Issue Patent No. : 6,900,972
 Issue Date : May 31, 2005
 Application No. : 09/829,339
 For : CIRCUIT INTERRUPTER WITH IMPROVED SURGE SUPPRESION

**REQUEST FOR CERTIFICATE OF CORRECTION OF PATENT
 UNDER 37 C.F.R. §§ 1.322 AND 1.323**

UNITED STATES PATENT AND TRADEMARK OFFICE
CERTIFICATE OF CORRECTION

FIG. 2

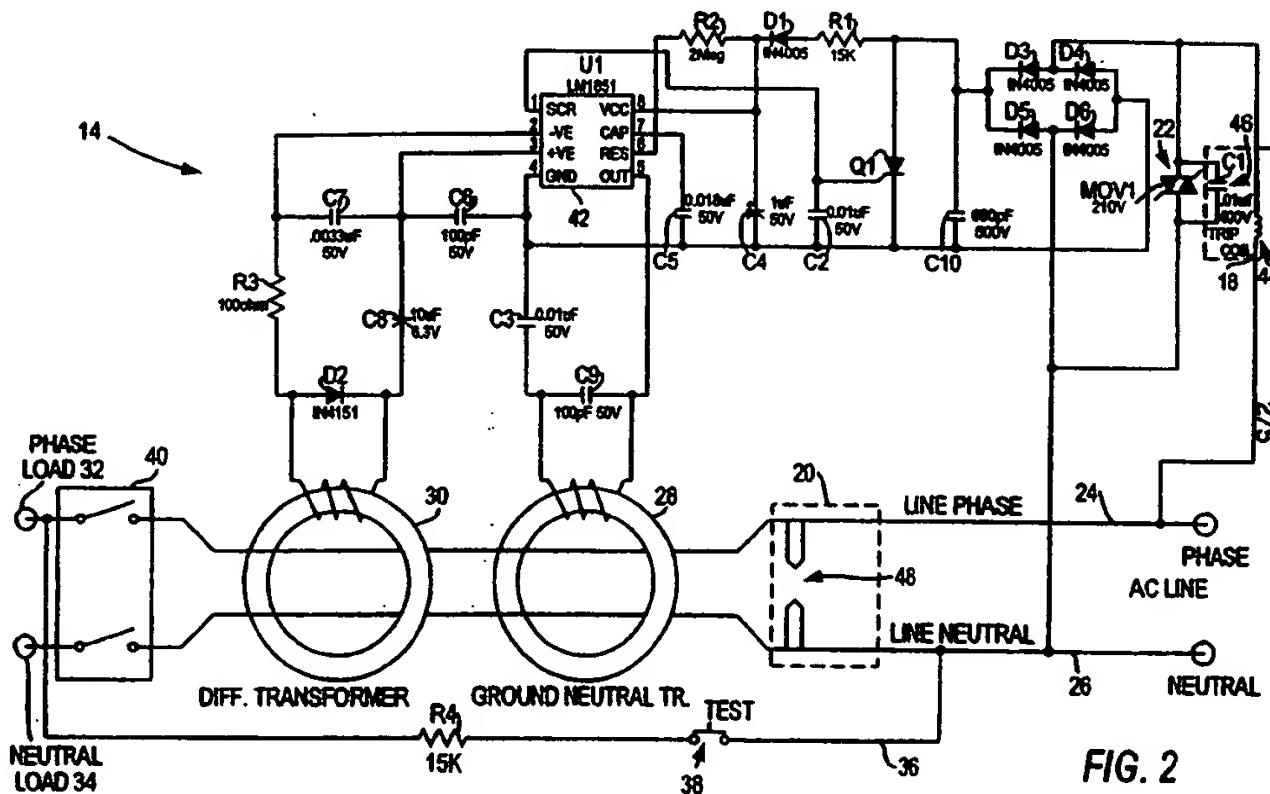
Attached are marked-up copies of drawing sheets 2-4 of the above-identified patent, corresponding to Figs. 2-4 respectively, with the charges thereon marked in red ink.. These drawings show a horizontal line, marked "line1", which should be removed. In addition, a vertical line, marked "line2" should be added. The line "line2" appears in the original drawings filed but not in the above-identified patent. Accordingly, the attached clean copies of Sheets 2-4, corresponding to Figs. 2-4, should replace the current drawings appearing in the above-identified patent. In addition, the figure appearing on the front page of the above-identified patent should be replaced with the attached clean copy of Fig. 2. This mistake occurred in good faith, is minor in character and does not constitute new matter.

Replace sheet 2 of the drawings (FIG. 2) with the sheet of drawings shown below:

FIG. 3

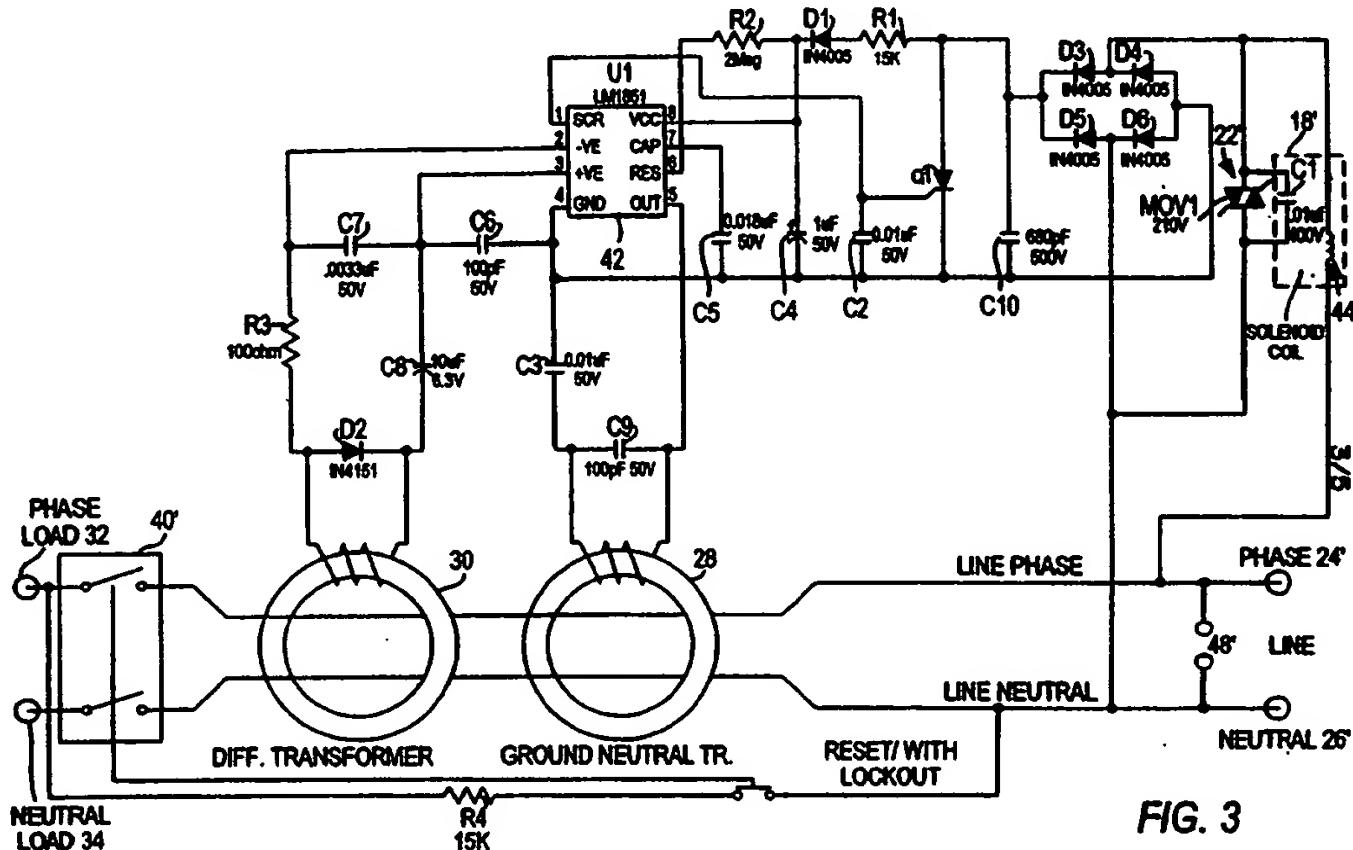
Replace Sheet 3 of the drawings (FIG. 3) with the sheet of drawings shown below:

FIG. 4

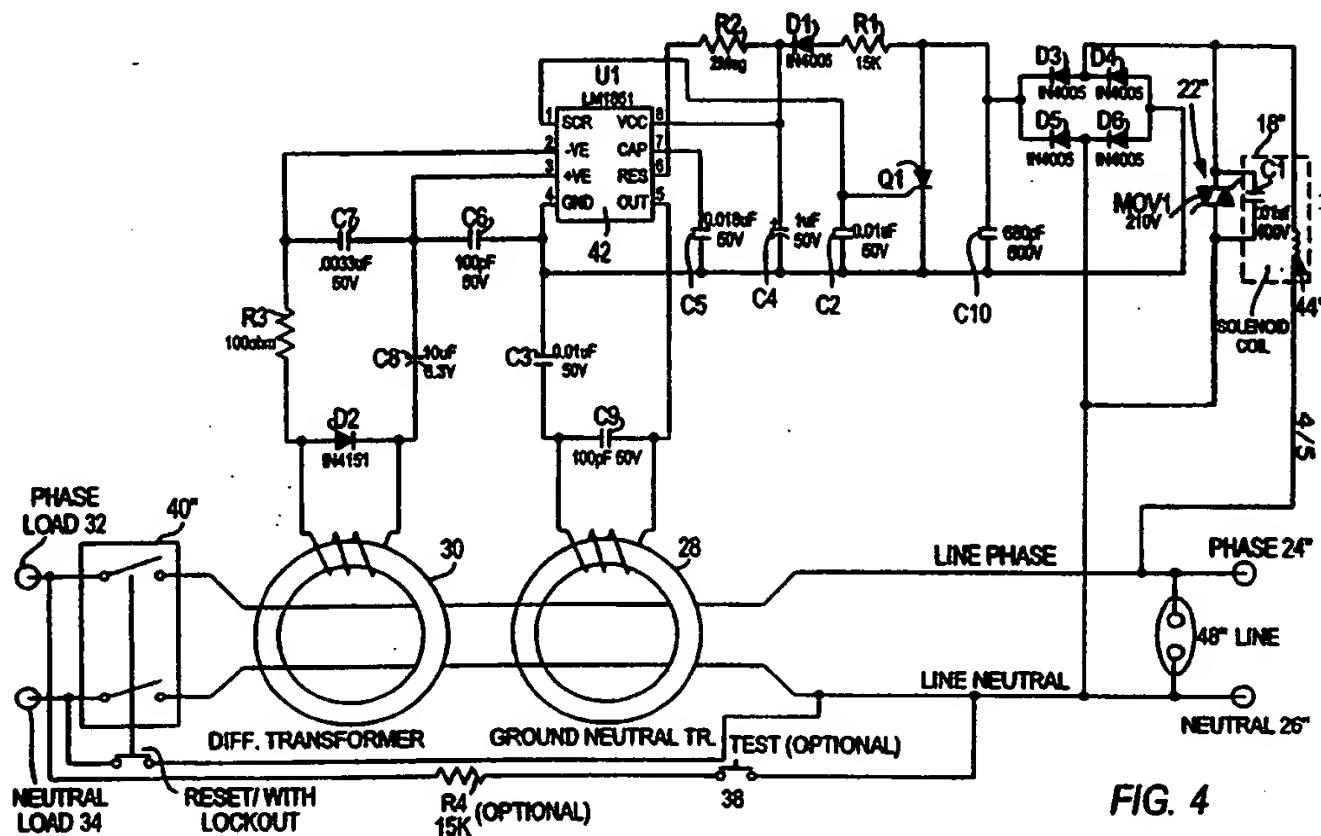
Replace Sheet 4 of the drawings (FIG. 4) with the sheet of drawings shown below:

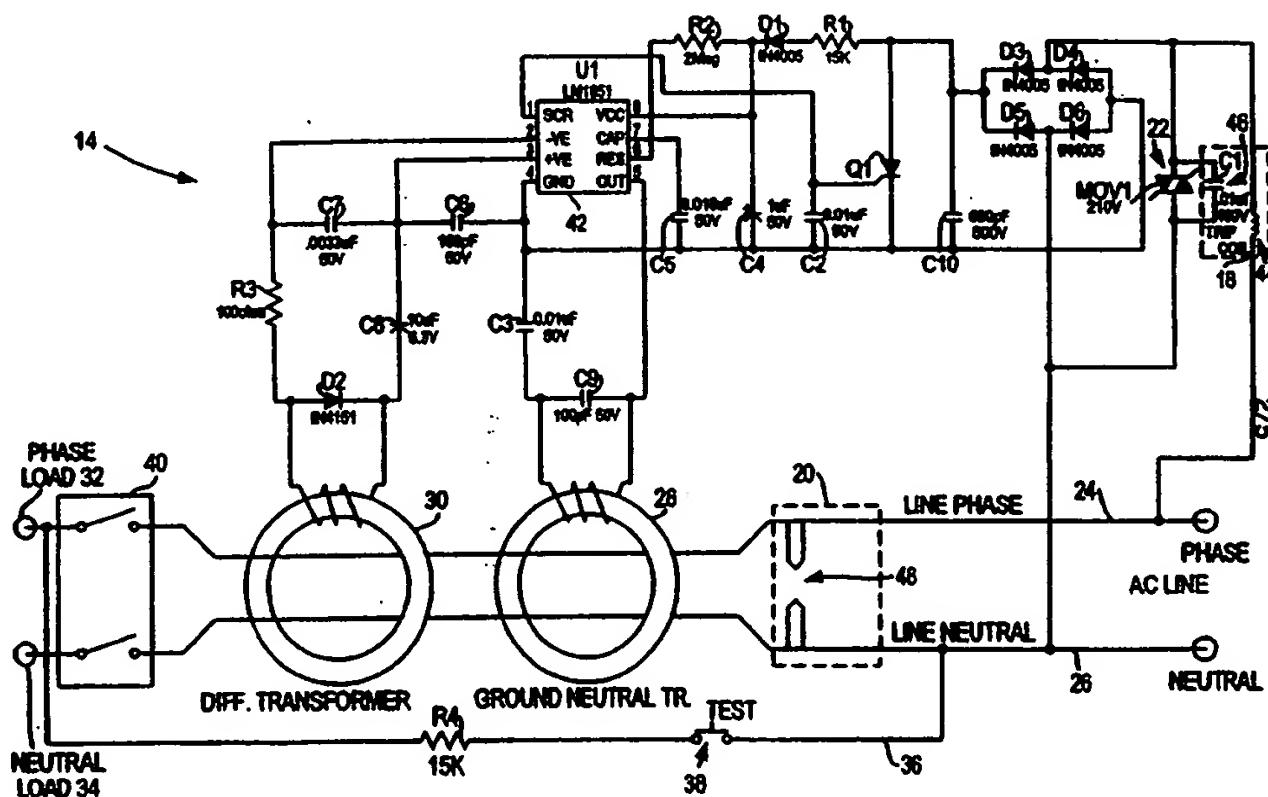
A Certificate of Correction for the above-identified patent has been prepared and is attached hereto. It is noted that pages 2, 3 and 4 of the Certificate show the corrected Figures 2, 3 and 4 respectively; the corrected Figure appearing on the front page of the patent appears on page 5 of the Certificate.

Replace the figure on the front page of the patent with the figure shown below:
